SIB 65 16 16

2019-10-24

RECALL CAMPAIGN 16V-071: DRIVER'S FRONT AIR BAG MODULE E82 E88 E90 E91 E92 E93

This Service Information Bulletin (Revision 5) replaces SI B65 16 16 **dated December 2018**.

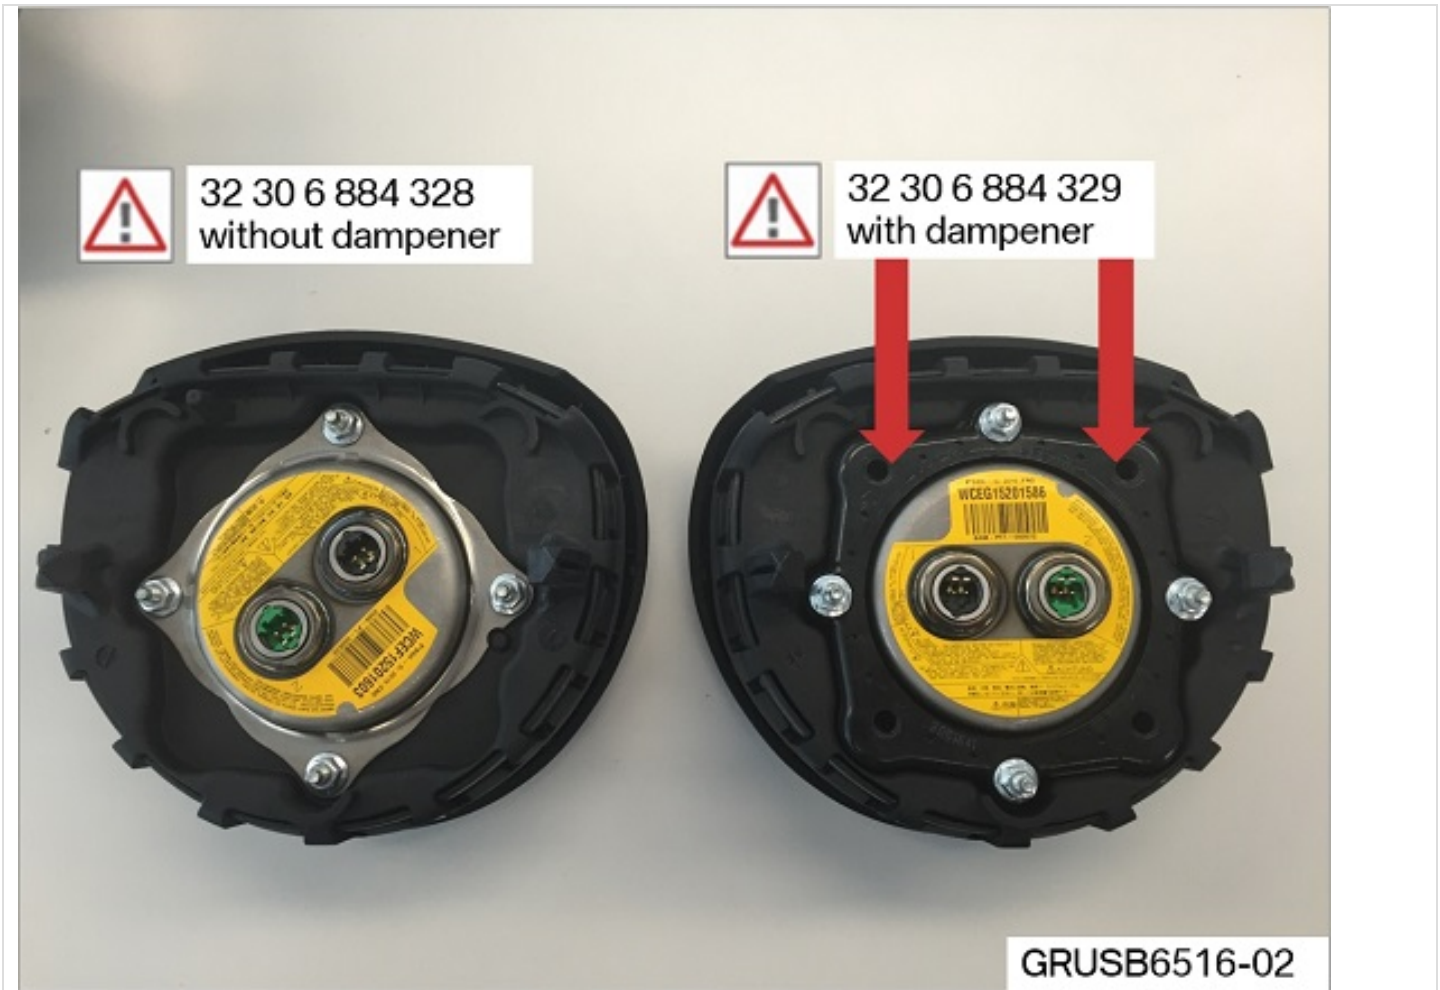
Note: **The original part removed from the vehicle may not exactly visually match the replacement part. This applies to vehicles originally equipped with or without a dampener. Refer to the photos below:**

32 30 6 884 664	airbag module driver's side base without vibration absorber (for all E82, E88, E91 and E92) or (for all E90 and E93)	1
OR		
32 30 6 884 664	airbag module driver's side with a vibration absorber (on E90 only with engine S65 or M57Y) and (on E93 only with engine S65 or N54T or N55)	1
